Product or Process Change Notice Approval (Customer)

PCN Number: PCN-0002-2014

Title: Change Product Part Number due to Change on the Coding Matrix. Change from ACT8865QI303-T to ACT8865QI305-T.

ACT8865QI303-T Enable/Disable Sequence

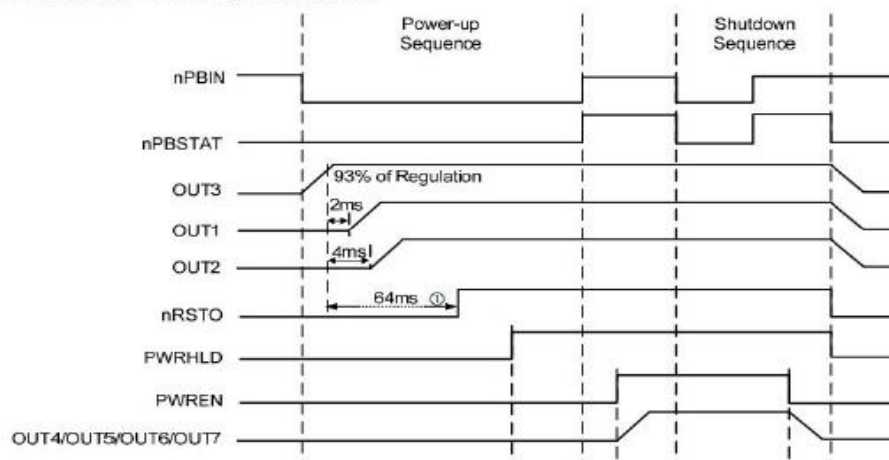
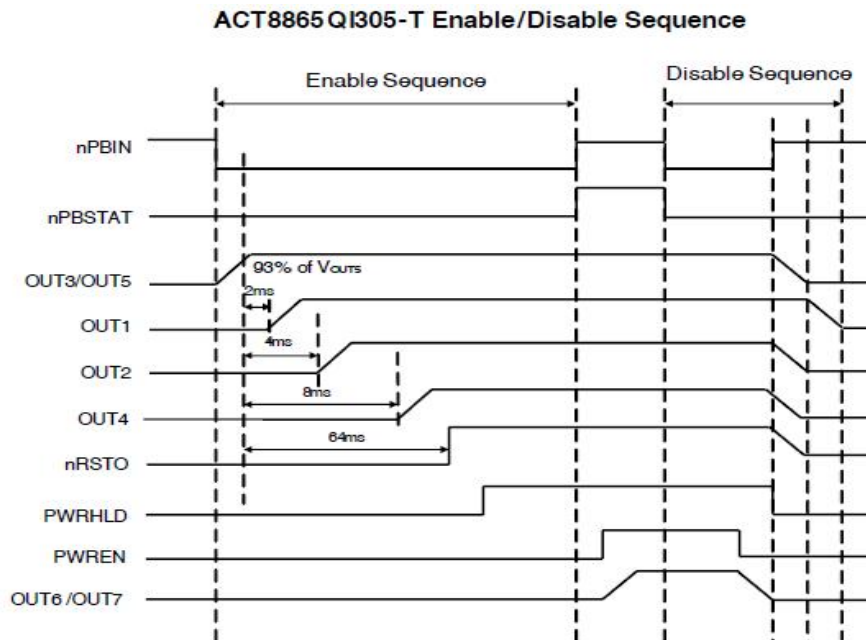
ACT8865QI305-T (AA51) is customized for Atmel's secure applications which will be used in 3 Platforms and 6 Applications based on ACT8865QI303-T; maybe it'll be used in SAM9-S5 platform, too. And the following is the only change based on ACT8865QI303-T:

1. OUT4=2.5V default on
2. OUT5=3.3V default on
